AMENDMENT REPORT

Culcairn Solar Farm

June 2020

Project Number: 18-441

Figure 1-1 Updated constraints and layout map.

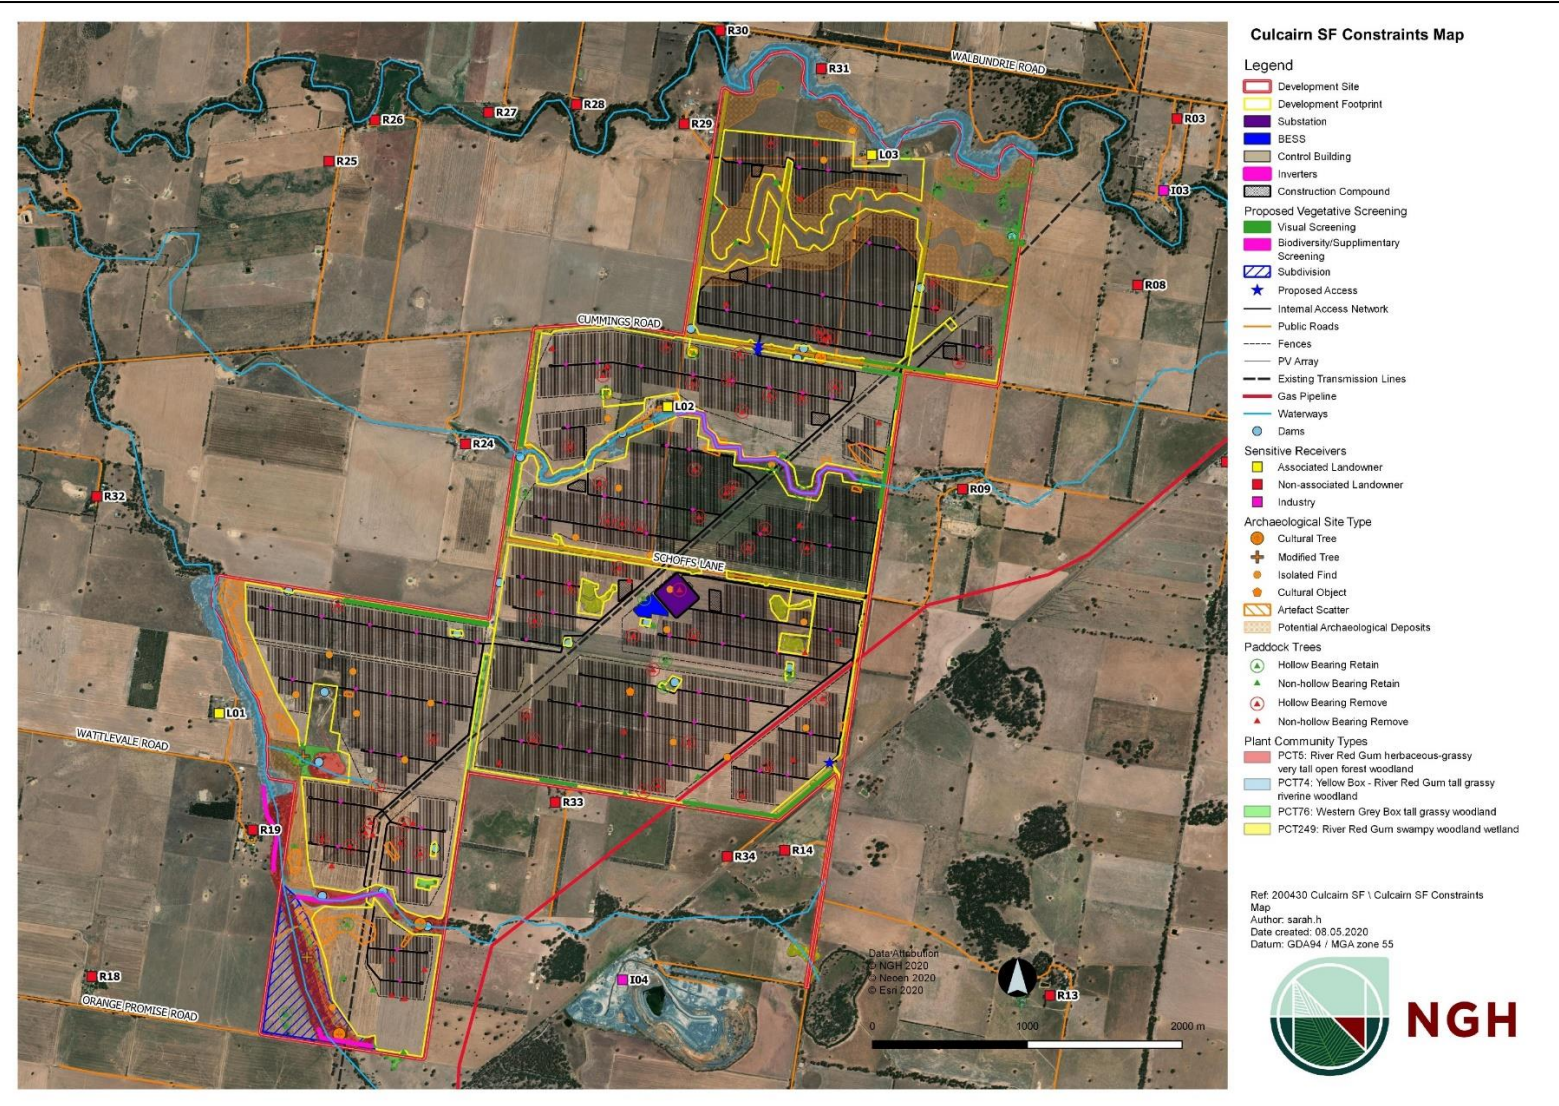
Key changes are further described below and detailed within Figure 1-1.

The original design for the Proposal included arrays of panels in the north-eastern corner of the proposal, near Billabong Creek. This panel array has since been removed, creating an approximate 980 m setback from Receiver R8 to solar infrastructure.

Adjustments have also been made to the western side of the development, to increase the setback of solar infrastructure from Receiver 24 by an additional 80 m (with the closest panel infrastructure located approximately 520 m from the residence) This additional setback of solar infrastructure is also supported by an additional 5m of additional vegetation screening to Receiver 24. The setback of solar infrastructure from Receiver 29 has also been increased by 70 m (with the closest panel infrastructure located approximately 350m from the residence).

The amendment of the project layout due to reduced number of PV modules required has also reduced the overall size of the development footprint, from 1126 ha to 1084 ha. This represents a saving of 42 ha and reduces the clearing of paddock trees from 99 to 77 trees.

Figure 1-2 Proposed landscaping

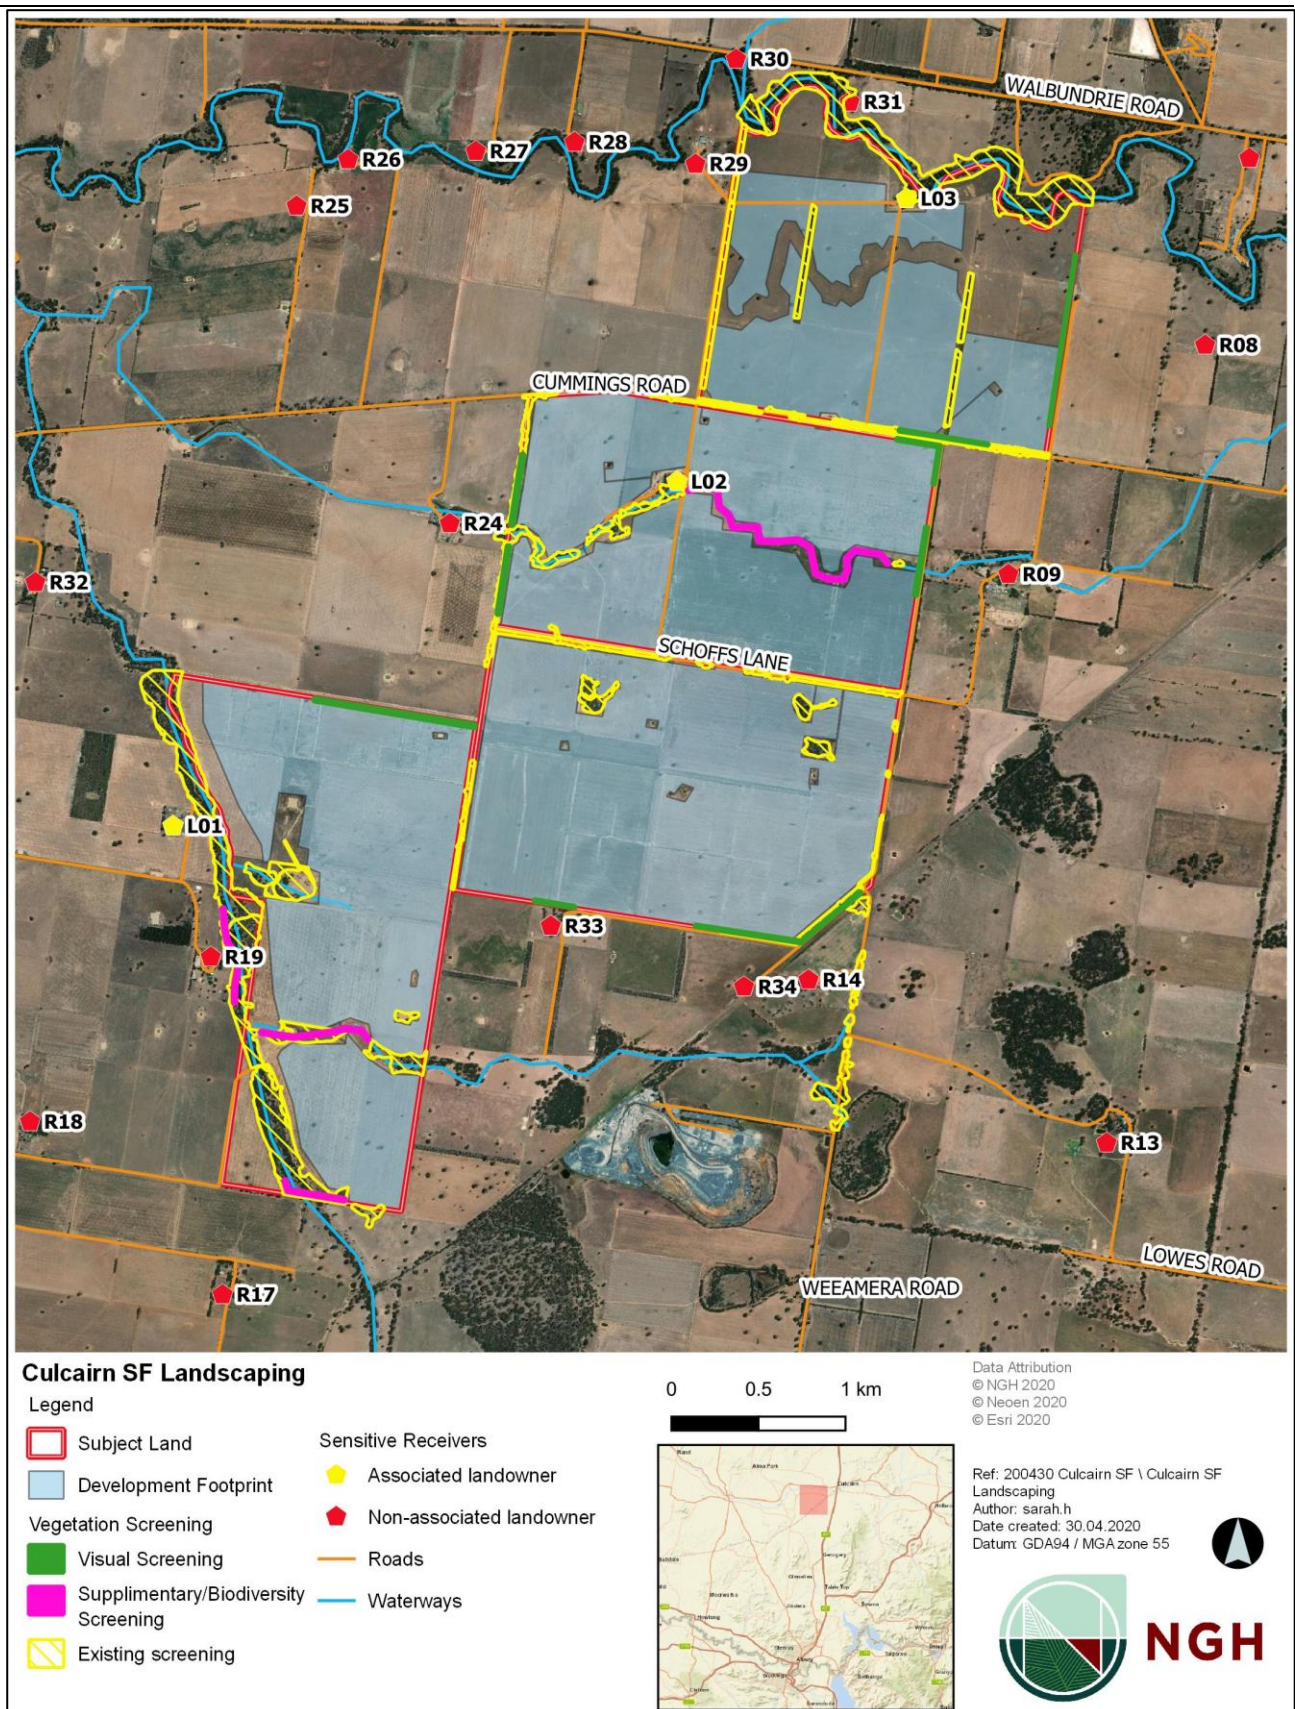
Additional vegetation screening has been proposed in two locations. An additional 5 m of vegetation screening for Receiver 24, and additional screening in the south-western to supplement existing vegetation screening in Back Creek, to reduce overall views corner for Receiver 17 and 19 (Figure 1-2 and Appendix E).

In addition to acting as a visual screen to Receivers R17 and 19, supplementary plantings have been proposed within the Back Creek riparian corridor to increase habitat connectivity and quality (Figure 1-2).

Supplementary planting is also proposed within the drainage lines that runs east-west through the north and south of the Proposal. The supplementary plantings will be designed to decreased habitat fragmentation and isolation, creating connectivity and a wildlife corridor through the proposal (Figure 1-2).
